KENYA ELECTRICITY GENERATING COMPANY PLC

**TENDER FOR SUPPLY AND DELIVERY OF COOLING WATER SYSTEM GI PIPES FOR SANG'ORO POWER STATION
(CITIZEN CONTRACTORS)**

Clarification No.1

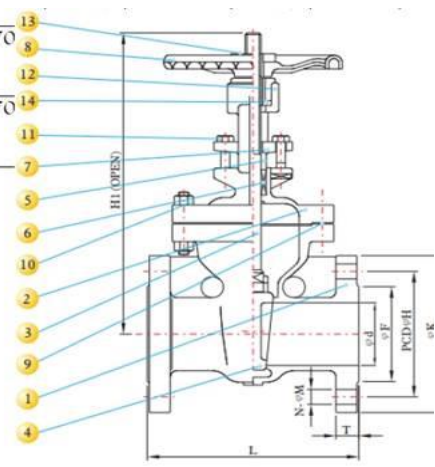
3. No.7 / No. 9 / No.11. / No.13 / No.15 / No.17 / No.19 all these stud bolts, please provide the material, size, bolt length..

- The lengths of the bolts is recorded and described on the table on the description of the bolts. The material for the

bolts and nuts is ASTM A193 Gr.B8/B7.
